**Re: Initial Submission Review: The Aurora Highlands – Preliminary Plat No. 10 and Final Plat (20204015-00; 2020-3027-00)**

## **INITIAL SUBMISSION REVIEW**

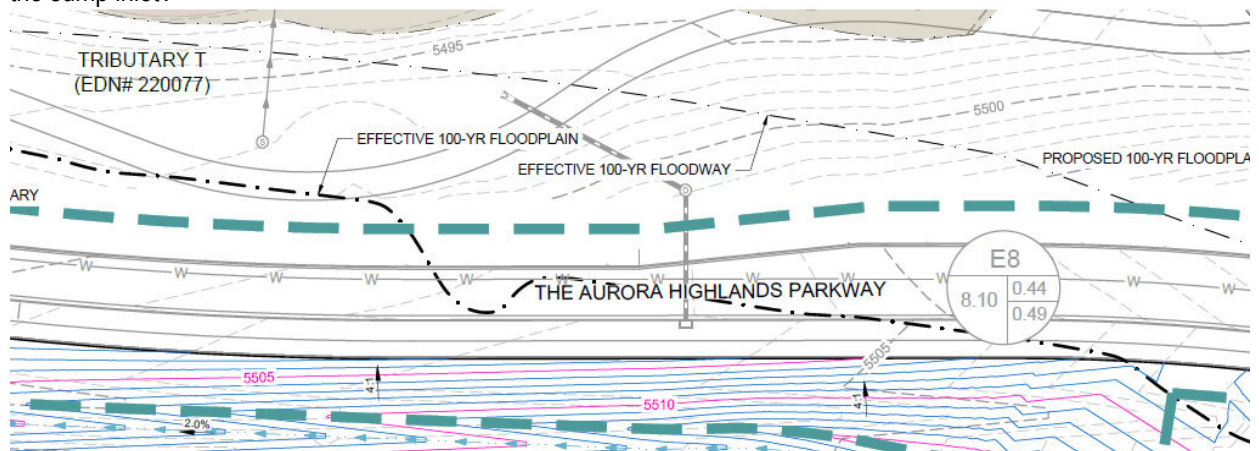
This letter was provided for the civil review (RSN 1465840) and are included here for your information. We have reviewed this proposal only as it relates to maintenance eligibility of major drainage features, in this case:

- The pipe outfall and the onsite detention basin overflow for EURV Pond 8508S.

- 1) The addition of EURV Pond 8508S provides an additional outfall to Tributary T. Please ensure a stable outfall at this location as part of final design.

**Response: Comment acknowledged; a stable outfall is now shown for EURV Pond 8505S.**

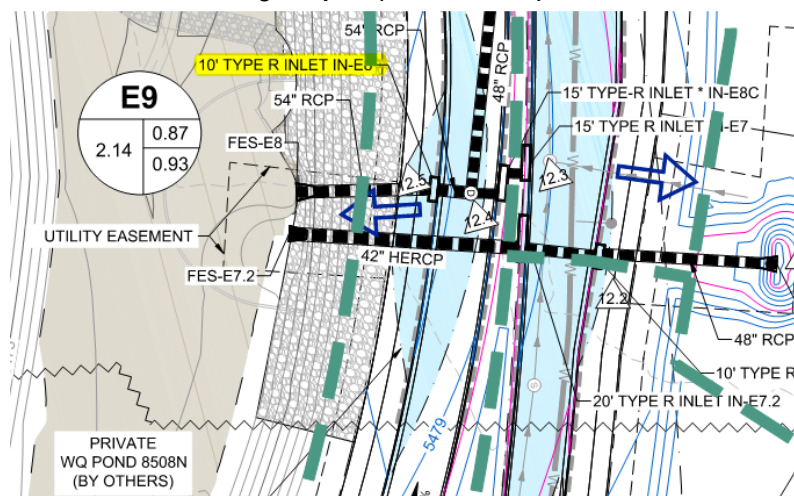
2) Please clarify the location of the sump inlet that collects the runoff for Basin E8. Will the inlet shown in the screenshot below capture any runoff or will the entirety of Basin E8 be directed to the sump inlet?

**Response: The inlet shown is an on-grade inlet that is placed due to super-elevation in the roadway and collects a minimal portion of Basin E8, the majority of the flows would be directed to the sump inlet farther west in The Aurora Highlands Parkway. Note this inlet was designed and constructed with The Aurora Highlands Subdivision Filing No. 1, The Aurora Highlands Parkway / Main Street Phase III, Final Drainage Report (COA# 219333).**
